AGENDA
PLANNING AND ZONING COMMISSION MEETING
CITY OF CREVE COEUR, MISSOURI
MONDAY, APRIL 2, 2018

**APPLICATION TO PLANNING AND ZONING COMMISSION
#18-011 FOR A MINOR SITE PLAN APPROVAL FOR THE PARKING
LOT ADDITION FOR SUSAN ROBERTS SALON AT
733 OLD BALLAS ROAD**

APPLICATION TO PLANNING AND ZONING COMMISSION #18-012 FOR A MASTER SIGN PLAN FOR LOU FUSZ AUTOMOTIVE NETWORK TO ALLOW FOR ADDITIONAL SIGNAGE SPECIFIC TO AUTOMOTIVE DEALERSHIPS

Figure 3: Close-up of the Applicants Landscape Plan.

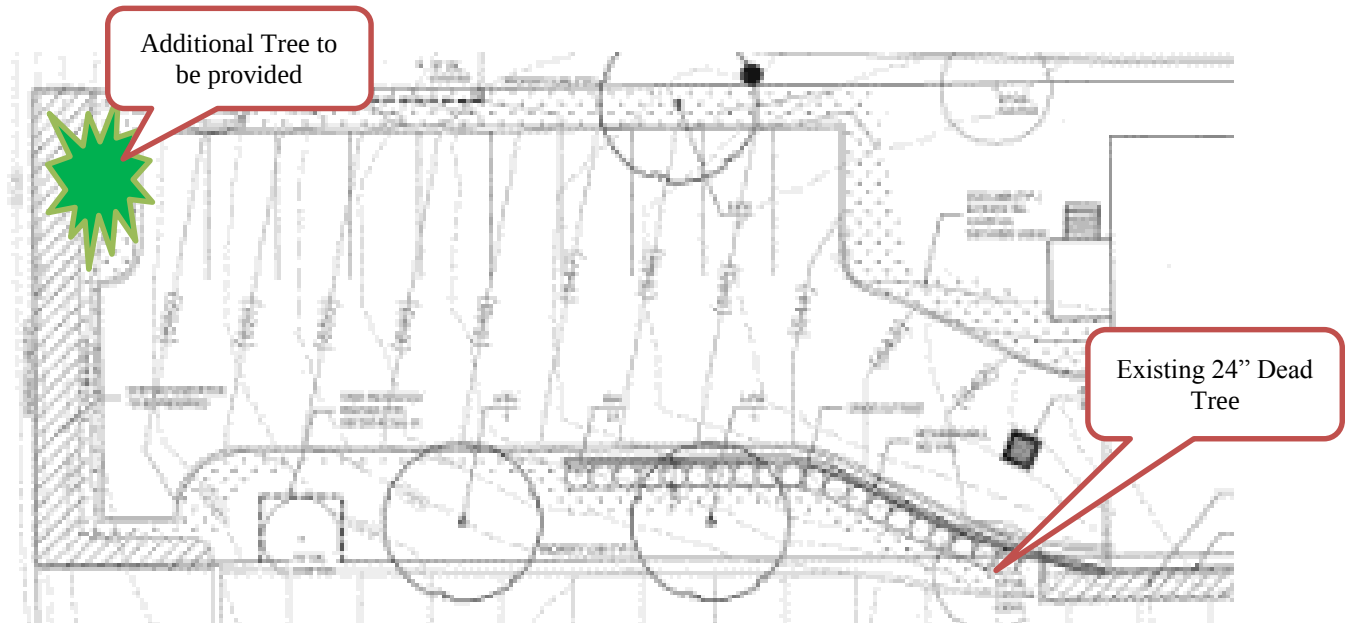
As stated above, the proposal includes one row of 10 parking spaces. The Landscape Plan indicates that 3 new trees are to be provided. However, Staff recommends that an additional tree be provided at the back end of the parking row to meet with the requirements of this section. There is an existing large 24" tree north east of the proposed parking that should provide sufficient shade. The plan also indicates that just off the property line there is an existing 24" dead tree. The construction of the retaining wall will have a further negative impact and this tree should be removed. Staff recommends that the Applicant work with the property owner to the south to have this tree removed and replaced.

The plans also indicate that the Trees a 2.5 inch caliper, where Section 405.540(F) requires a minimum of 3" caliper. Additionally, all landscaping is to be maintained per the approved plans, with an underground irrigation system.

5. The Applicant shall obtain written authorization from the adjacent property owner for any work within their property.
6. The Landscape Plan shall be revised to indicate that the minimum caliper tree is 3 inches, and that an additionl tree shall be provided at the end of the parking row as discussed in the Staff Report and in compliance with Section 405.540(F), and that the exsiting dead tree shall be removed and replaced.

Figure 4: Close-up of the site plan showing the existing accessible parking space.

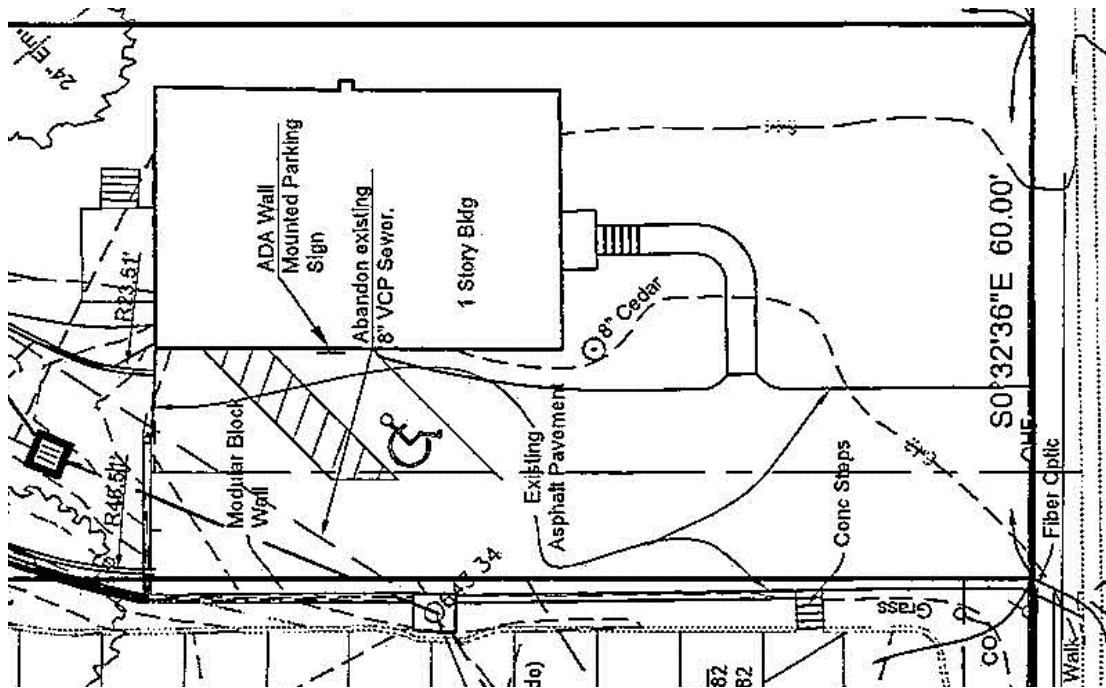
With the additional 10 parking spaces provided, the Building Code requires that at least one of the spaces is made van accessible. The Applicant has indicated that the existing one accessible space is adjacent to the building and the revised site plan emailed on March 21 shows this area. However, the space looks like it would block a portion of the drive aisle. Section 405.810(A)(1) requires a minimum of 22 feet for drive aisles. Therefore, Staff has included a condition that this space may need to be reworked or made to be a parallel space to provide sufficient passing of vehicles. If the space is required to be located into the new parking area, adequate pedestrian access will need to be included.

3. A black wrought-iron style safety barrier fence is approved if the Building Code requires such for the retaining wall.
4. The Site Plan shall be revised to provide for a minimum two-way drive aisles ofttwenty-two (22) feet wide, per Section 405.810(A) of the Zoning Ordinance. The Applicant shall coordinate with the Chief Building Official to determine the appropriate location and/or placement of the accessible parking space.

Figure 1: Applicants Site Plan with signage indicated.

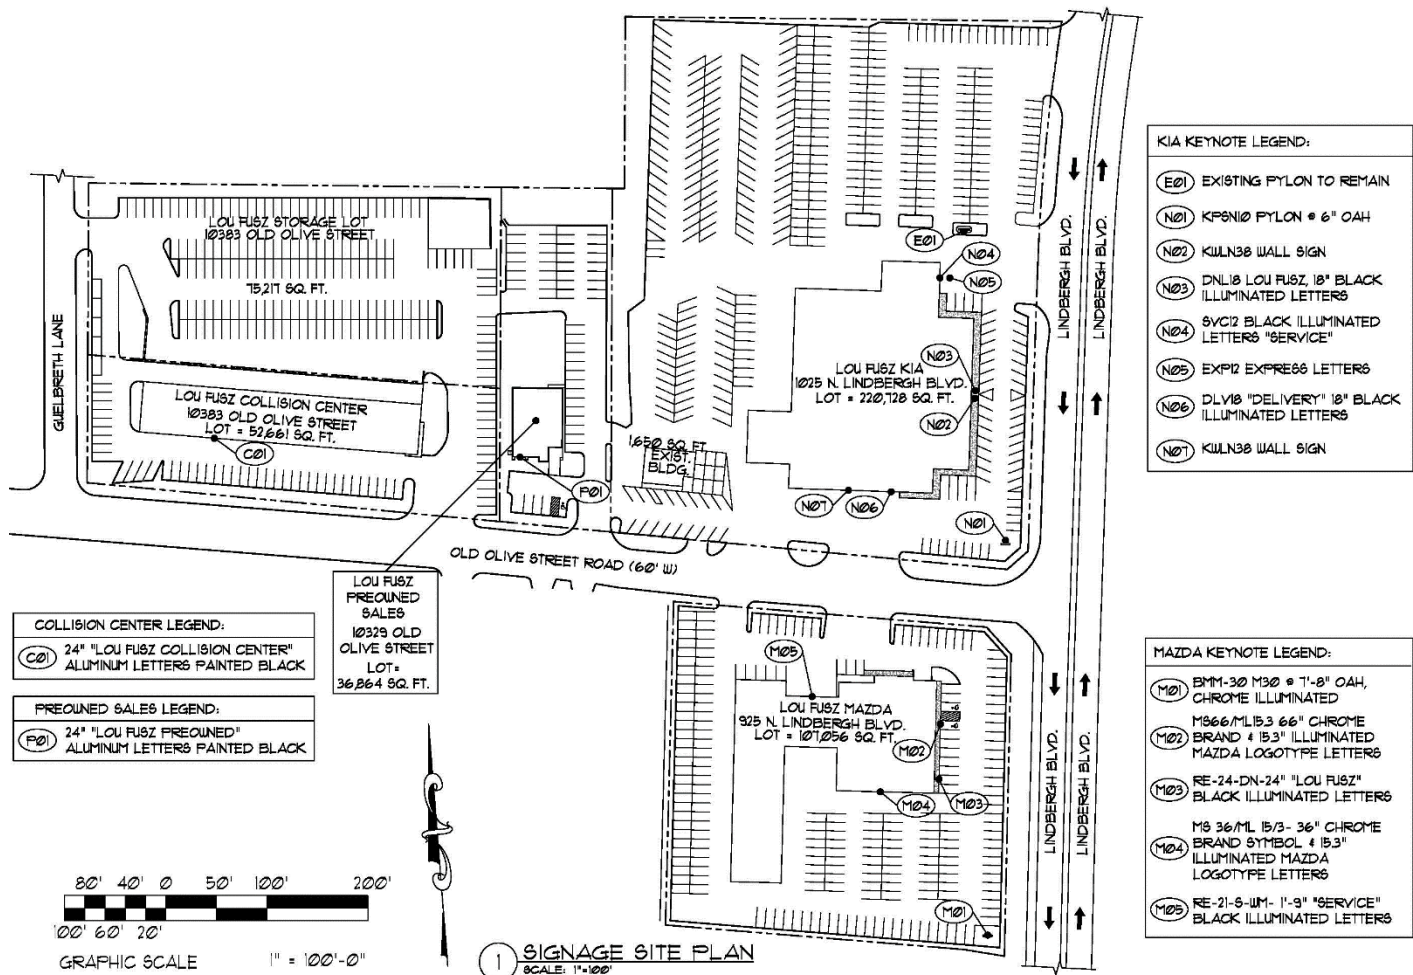
The site plan does indicate a second ground sign (identified as NO1) at the north corner of Lindbergh Boulevard and Old Olive Street Road for the Lou Fusz Kia Dealership. However, this was mistakenly kept from an earlier version and no details of the sign has been included in the packet, therefore a condition of approval includes that a ground sign second sign at this location is not included as part of the approval.

- The ground sign identified on the site plan NO1 at the north corner of Lindbergh Boulevard and Old Olive Street Road is not permitted.
- Should the pre-existing, non-conforming pylon sign at 1025 N. Lindbergh Boulevard be removed, damaged, or destroyed beyond 50% of the value, any new sign shall comply with the current Sign Regulation for a low monument signs.

Figure 10: Proposed Monument Sign

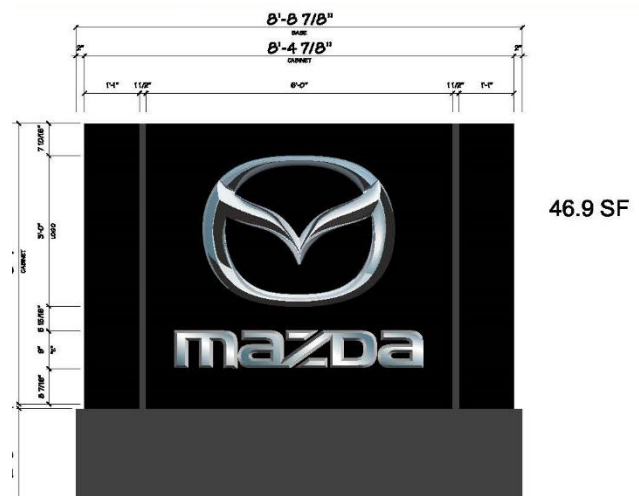
The Applicant has indicated that the monument sign cannot be made smaller. Mazda corporate only purchases so many sizes and if we reduce the size of the monument then the logo will suffer.

Figure 1: Applicants site plan drawing submitted on March 19th.

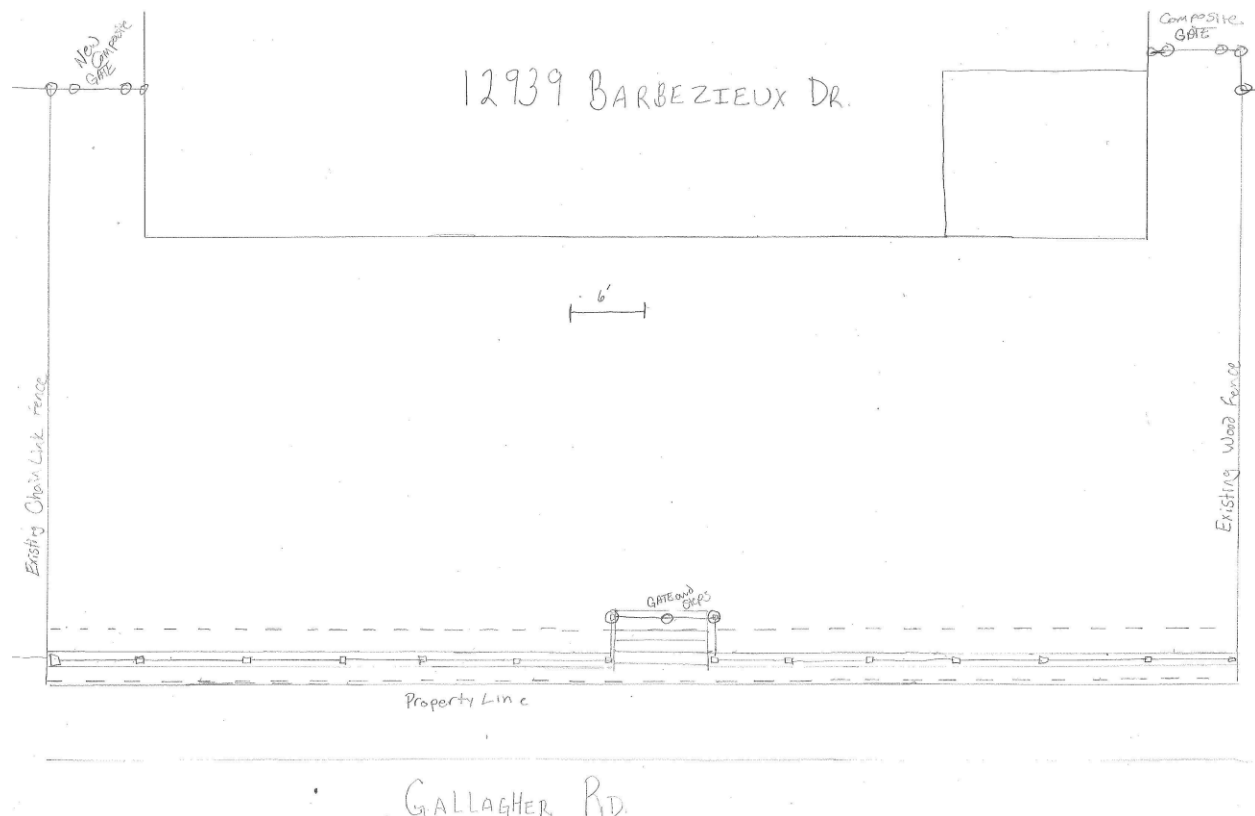
The Applicant is proposing a 6 foot tall privacy fence to be placed on top of a two-foot retaining wall along the rear property line. The material for the fence is a composite material. This would make the fence appear to be 8-feet tall as viewed from Gallagher Road. There are no example photos or cut sheet of the fence design other than the Applicant's black and white drawing. However, he will bring a sample of the material for the meeting.

Figure 1: Lot A and Lot B of the proposed subdivision

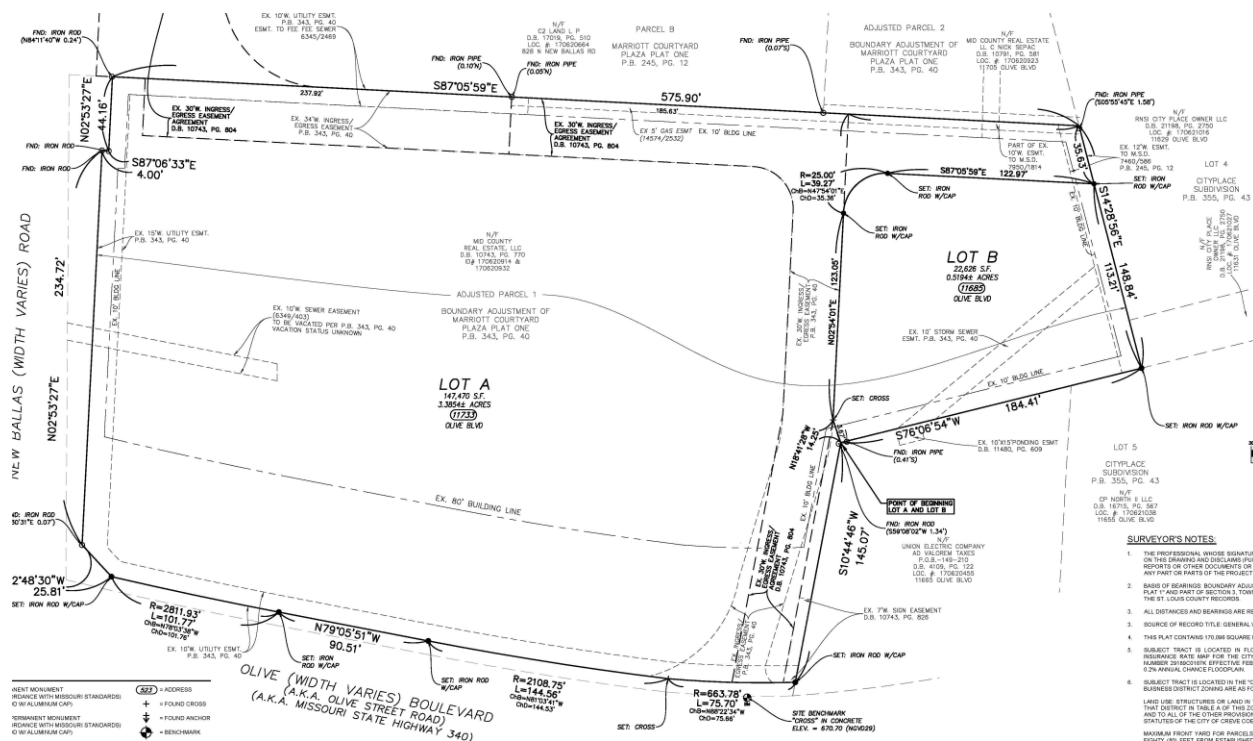
The area is currently a parking lot for the Aldi retail center. There are no current proposals for development at this time. The lot is being created, in anticipation of the relocation of the Ameren substation to this area, and the future redevelopment of 11665 Olive Boulevard. Therefore, further review with the remaining Zoning Regulations are not provided. However Staff has included a condition of approval that the building setback lines be included for Lot B, and revised setback lines provided for Lot A per Section 405.370(E)(4) be included on the plat.

Additionally, the City has requested an easement along/near the north side of the property for the existing utility duct bank that was installed in anticipation of the Olive TDD's burial of the power lines. The easement would allow for such work in this area should that project ever move forward. The Applicant has indicated agreement with providing the easement, and therefore a condition of approval includes that one be included as part of the final Plat in coordination with the City's Public Works Department.
